Western Sub Regional RTEP: AEP Supplemental Projects

May 16, 2025

AEP Transmission Zone: Supplemental S2470.1-.7 Cancellation

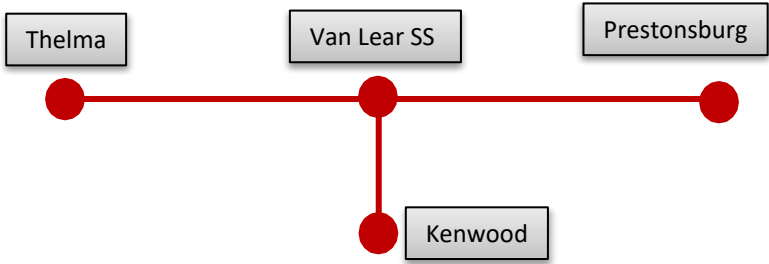
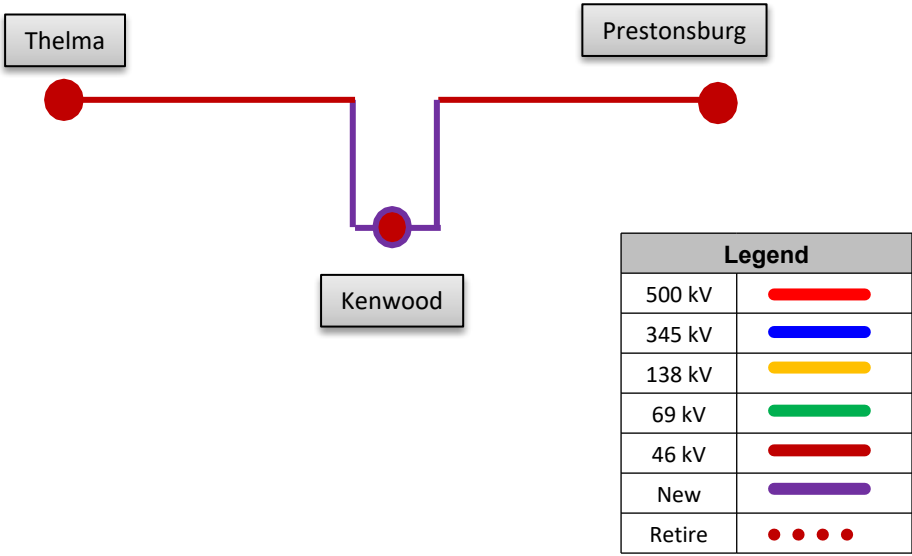
Reason for cancellation of the Kenwood Loop solution: The Need AEP-2020-AP29 will be addressed by the updated scope of b3361.
